URBAN DESIGN COMMITTEE

URBAN DESIGN COMMITTEE STAFF REPORT

APPLICATION NUMBER	Urban Design Record #23007
APPLICATION TYPE	Advisory Review
ADDRESS/LOCATION	N 48th Street and Madison Avenue (2747 N 48th Street)
HEARING DATE	February 7, 2023
ADDITIONAL MEETINGS	N/A
APPLICANT	Adam Criswell, akcriswell@speedwayproperties.com
STAFF CONTACT	Collin Christopher, 402-441-6370, cchristopher@lincoln.ne.gov

URBAN DESIGN COMMITTEE STAFF REPORT

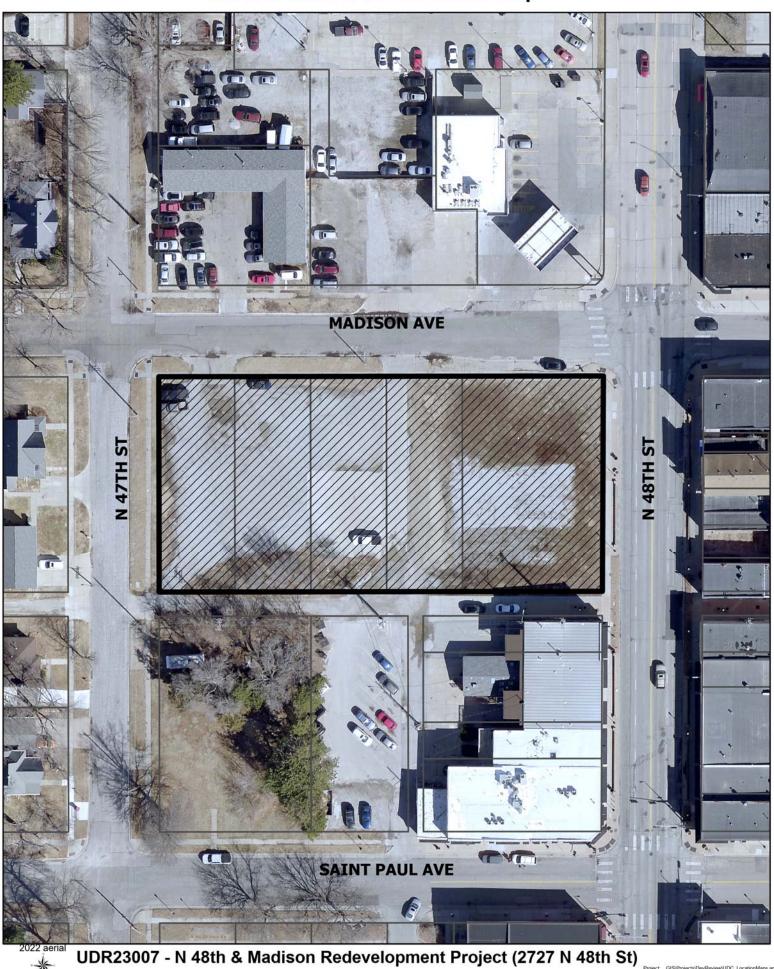
Compatibility per Staff Analysis: Street trees would typically be required along N 47th Street, N 48th Street and Madison Avenue. However, there are complicating factors here, as there often are on infill and redevelopment sites. Along the N 48th Street side, the available right-of-way is quite narrow and street trees have typically not been required along this stretch in order to accommodate pedestrian pathways. On the N 47th Street side, parking lot trees are shown inside of the right-of-way, but street trees are not shown. There is an overhead powerline that runs along this side of N 47th Street that would prohibit street tree plantings here, so none will be required in this location. Finally, the applicant has shown three street tree plantings along the Madison Avenue side. While the required street tree spacing is always a bit of a negotiation based on site limitations, redevelopment of a full block face like this would typically result in a requirement of more like five street trees, spaced 45-50' apart. The

Committee should weigh in on the appropriate number of street trees to be planted along Madison Avenue.
